UNITED NUCLEAR
C O R P O R A T I O NIn Reply Refer to: NLS:REK-707 *sek*P. O. BOX 1283
365 WINCHESTER AVENUE
NEW HAVEN, CONN. 06508
777-5361

May 20, 1966

SUBJECT: Shipping Containers

Reference: (1) SNM-33, Section 700
(2) SNM-368, Section 8
(3) SNM-777, Section 700

SKETCH 700-1

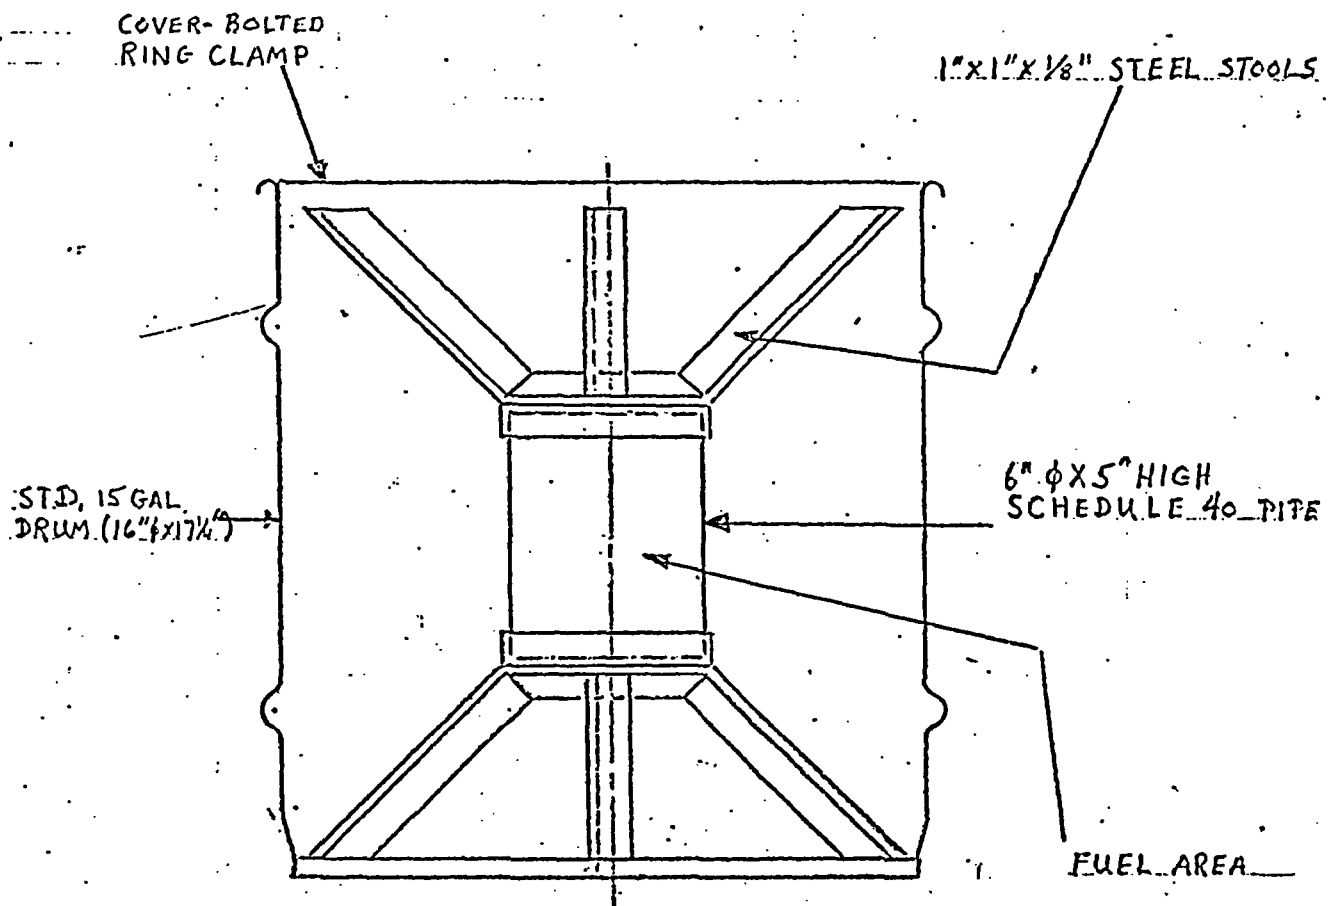
B. E. 1351

- (1) Inner container: 5' inch high x 6 inch I.D. Schedule 40 pipe with 1/4 inch welded steel plate bottom (approximately 2.4 liters).
- (2) Inner Container Closure: 8 3/4-inch dia. x 1/4-inch steel plate top fastened to inner container by four equally spaced 3/8-inch bolts.
- (3) Inner Container Supports: Upper and lower metal "stools" constructed of 1 inch x 1 inch x 1/8-inch steel.
- (4) Outer Container: 15 gallon drum - specification 6A, 6B, 6C, 6J, 17C or 17 H.
- (5) Outer Container Closure: 16 gage steel head with bolt-locking ring clamp utilizing not less than 3/8-inch steel bolt or lock nut, or equivalent device, with a tamper-proof seal.
- (6) Non-Stacking Device: None

- (1) Fissile Class I: None
- (2) Fissile Class II: Not to exceed 9 (4.4 transport units per container).
- (3) Fissile Class III: Not to exceed 19 total (may be mixed with B.E. 1452, 1483, and/or 2208 Containers).

- (1) Structural Determination: Drop tested.
- (2) Weight Limitations: Not to exceed 75 lbs max. gross weight for container and contents.

SKETCH 700-2

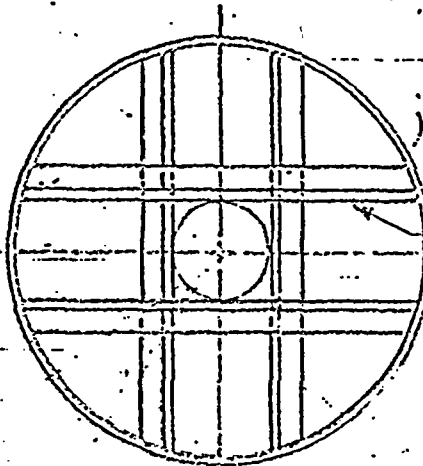
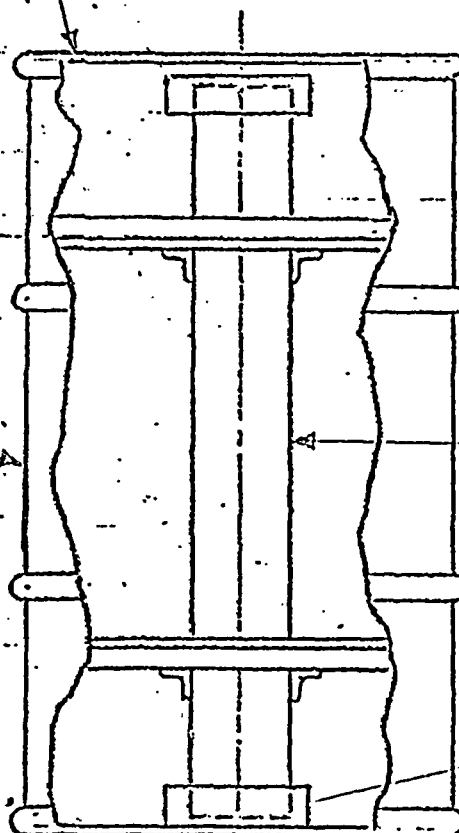
1. Container Number or Identification
B. E. 1452
2. Description of Container
 - (1) Inner Container: 5 inch I.D. Schedule 40 Pipe not to exceed 30 inches in length.

- (2) Inner Container Closure: Standard threaded pipe caps with at least 5 threads engaged.
 - (3) Inner Container Supports: 4 to 8 spokes constructed of 3/16-inch x 2 inch x 2 inch angle iron attached to upper and lower portion of inner container.

- (4) Outer Container: 55 gallon drum - Specification 6A, 6B, 6C, 6J, 17C, or 17H.
 - (5) Outer Container Closure: 16 gage steel head with bolt locking ring clamp utilizing not less than 3/8-inch steel bolt or lock nut, or equivalent device, with a tamper-proof seal.

7. Special Restrictions
 - (1) Drums will not be stacked.
 - (2) When shipping uranium-bearing salts which are soluble in water or will thermally decompose during the standard one hour fire test, each container will be limited to 350 grams U-235.

- (3) Containers will be marked in accordance with 49 CFR 73 and 78 (ICC Regulations) and 10 CFR 71 (AEC Regulations).
8. Design Requirements
 - (1) Structural Determination: Design evaluation.

- (2) Weight Limitations: Not to exceed 120 lbs. in inner container.
9. Shipping Criteria
 - (1) Fissile Class I: None
 - (2) Fissile Class II: Must meet "40 unit rule."

SKETCH 700-3

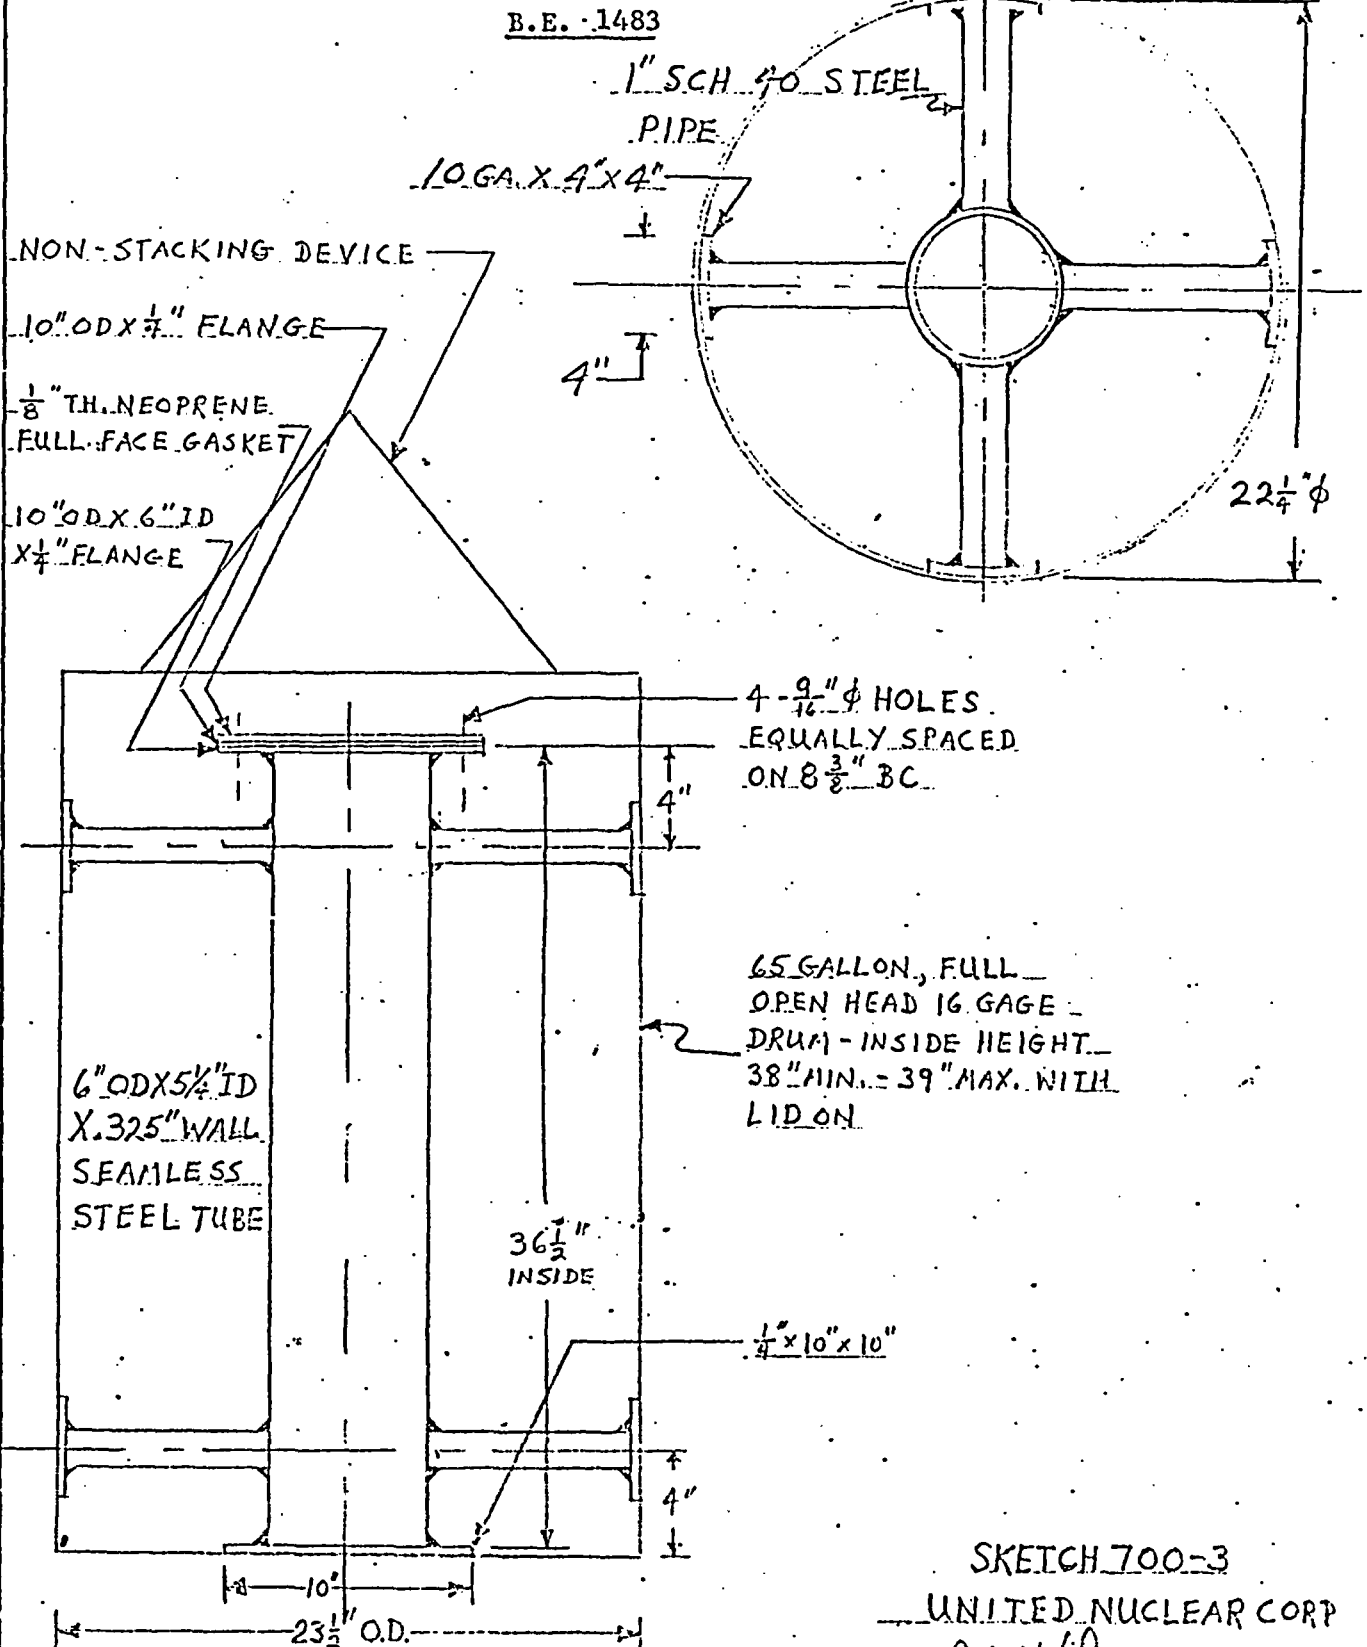
B.E. 1483

- (1) Inner Container: 5 1/4-inch I.D. x 36 inch long 0.325 inch thick seamless steel pipe with 10 inch dia. x 1/4-inch steel plate welded to bottom and 10 inch O.D.-6 inch I.D. x 1/4-inch steel flange welded to top.
- (2) Inner Container Closure: 10 inch dia. x 1/4-inch steel plate top fastened to inner container by four equally spaced 9/16" bolts.
- (3) Inner Container Supports: 4 spokes constructed of 1 inch schedule 40 pipe attached to top and bottom of inner container.
- (4) Outer Container: 65 gallon drum-Specification 6A,6B,6C,6J,17C or 17H.
- (5) Outer Container Closure: 16 gage steel head with bolt-locking ring clamp utilizing not less than a 3/8-inch steel bolt or lock nut, or equivalent device, with a tamper-proof seal.
- (6) Non-stacking Device: 1/8-inch x 2 1/2-inch metal strap forming blunted point.

- (1) Fissile Class I: None
- (2) Fissile Class II: Not to exceed 9 (4.4 transport units per container).
- (3) Fissile Class III: Not to exceed 19 total (may be inter-mixed with B.E. 1351, 1452, and/or 2208 containers).

- (1) Drums will not be stacked.
- (2) When shipping uranium-bearing salts which are soluble in water or will thermally decompose during a standard one hour fire test, each container will be limited to 350 grams U-235.
- (3) Containers will be marked in accordance with 49 CFR 73 and 78 (ICC Regulations) and 10 CFR 71 (AEC Regulations).

- (1) Structural Determination: Drop tested.
- (2) Weight Limitations: Not to exceed 120 lbs in inner container.

SKETCH 700-4

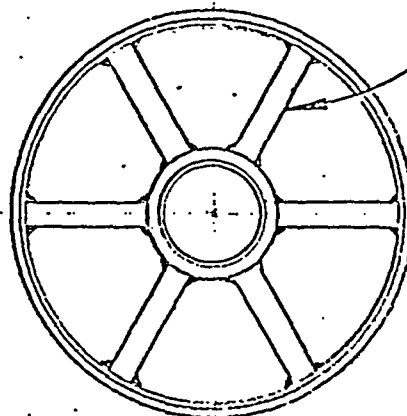
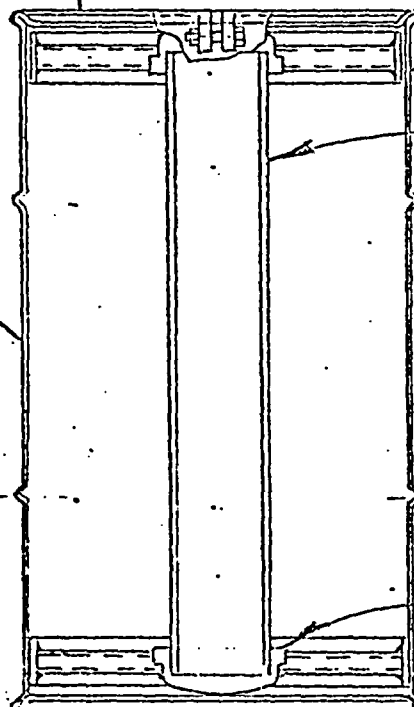
1. Container Number of Identification
B. E. 2208 - General Purpose Shipping Container
2. Description of Container
 - (1) Inner Container: 5 inch I.D. Schedule 40 pipe.

- (2) Inner Container Closure: Standard threaded pipe caps with at least 5 threads engaged.
 - (3) Inner Container Supports: 4 to 6 spokes constructed of 1 inch schedule 40 pipes welded to pipe caps and 3/16-inch x 3 inch support ring.

- (4) Outer Container: 55 gallon drum-Specification 6A,6B,6C,6J,17C, or 17H.
 - (5) Outer Container Closure: 16 gage steel head with bolt-locking ring clamp utilizing not less than a 3/8-inch steel bolt or lock nut, or equivalent device, with a tamper-proof seal.

7. Special Restrictions
 - (1) Drums will not be stacked.
 - (2) When shipping uranium bearing salts which are soluble or will thermally decompose during a standard one hour fire test, each container will be limited to 350 grams U-235.

- (3) Containers will be marked in accordance with 49 CFR 73 and 78 (ICC Regulations) and 10 CFR 71 (AEC Regulations).
8. Design Requirements
 - (1) Structural Determination: Drop tested.

- (2) Weight Limitations: Not to exceed 132 lbs in inner container.
9. Shipping Criteria
 - (1) Fissile Class I: None
 - (2) Fissile Class II: Must meet "40 unit rule."
